ADDENDUM 04 TO CONTRACT DOCUMENTS

**MISSISSIPPI RIVER SEDIMENT DELIVERY SYSTEM – BAYOU DUPONT
(BA-39)**

FILE NUMBER: P27204UL

**COASTAL ENGINEERING DIVISION
ADDENDUM 04 TO BID DOCUMENTS**

ATTACHMENT B

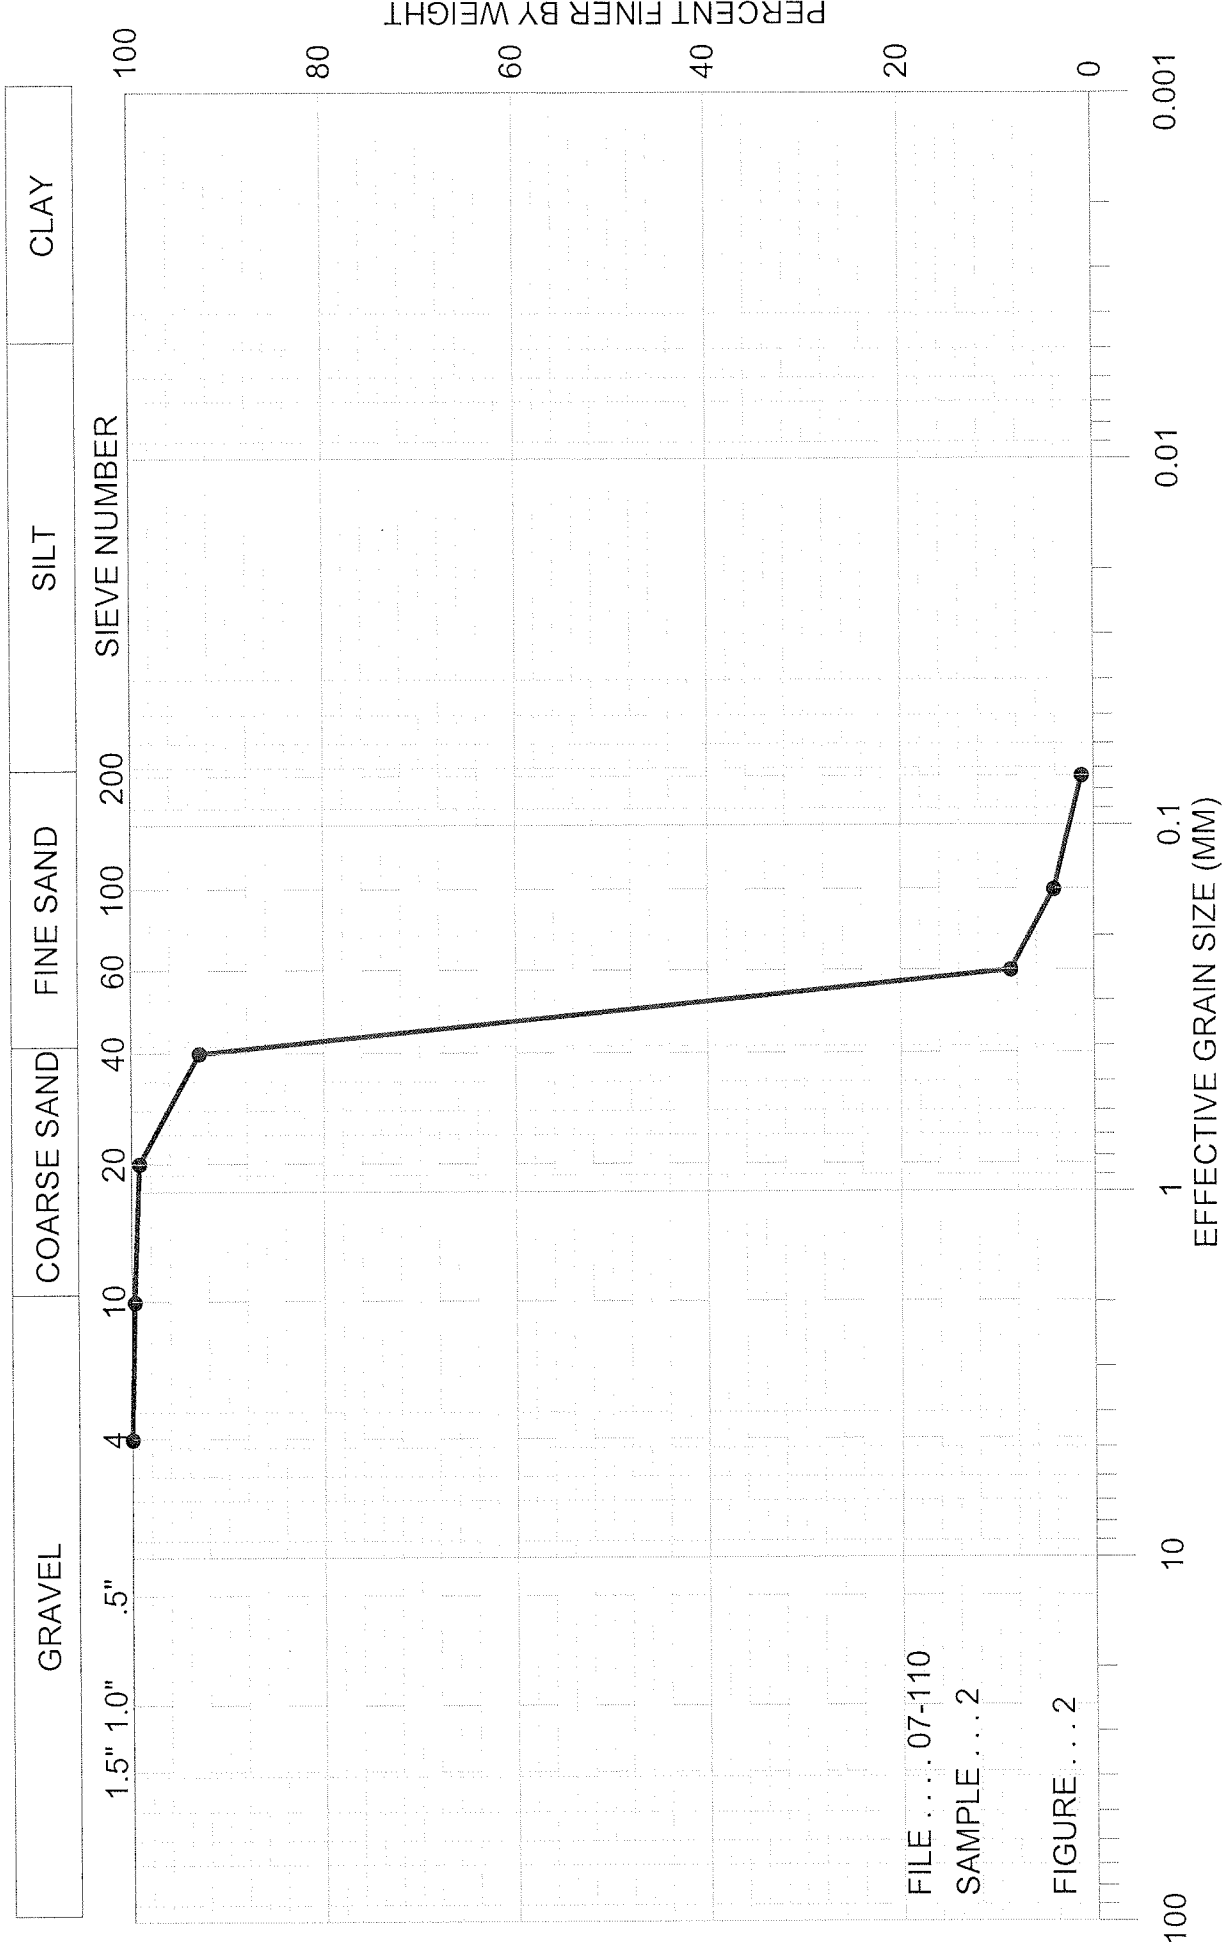
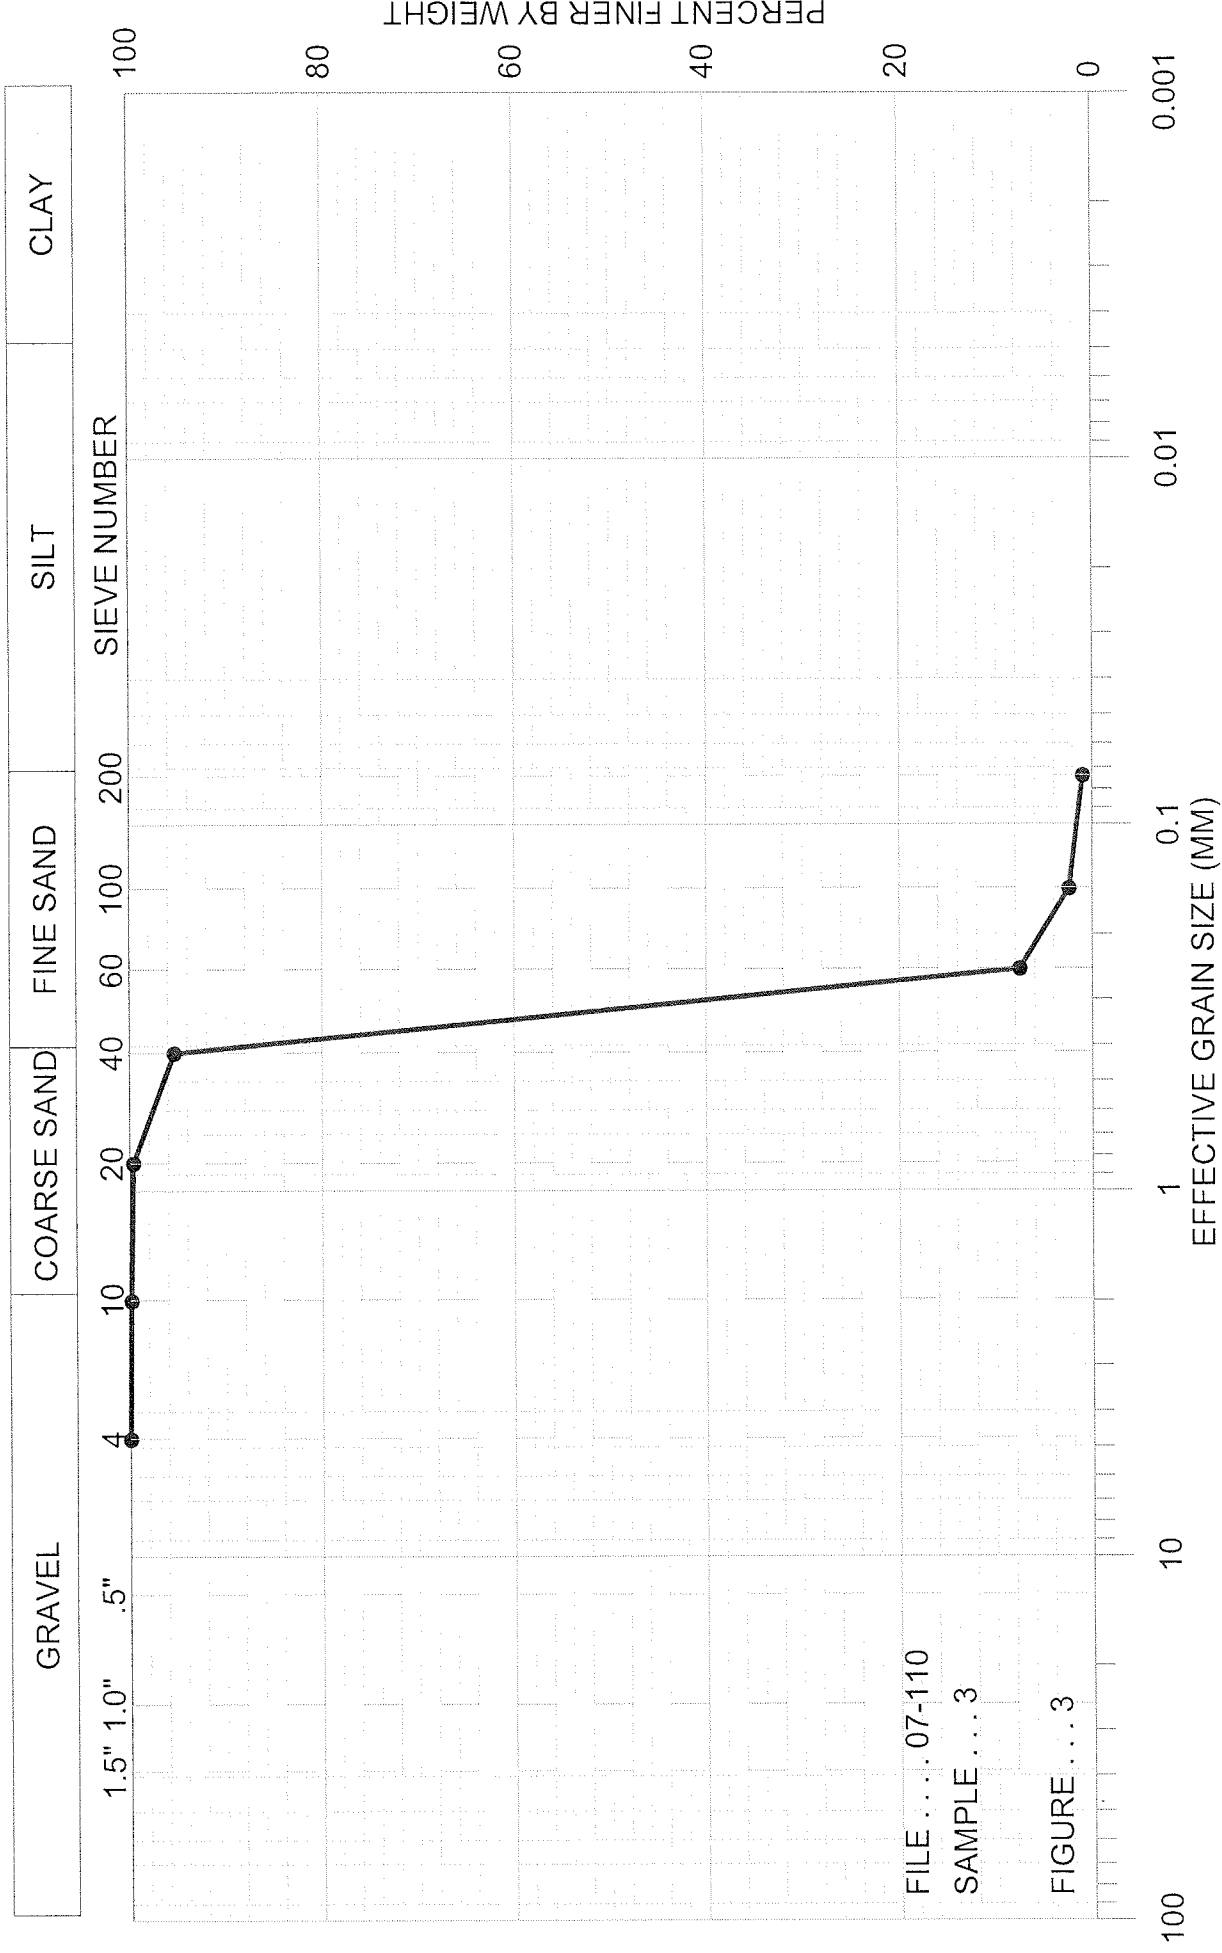
- 3.6 Question: Please provide sieves/gradation curves for the borings provided in the specification, especially B-1B, B-2B, & B-3B.

Response: Grain size distribution test results obtained from borings B-1B, B-2B, and B-3B are included in **Attachment B**.
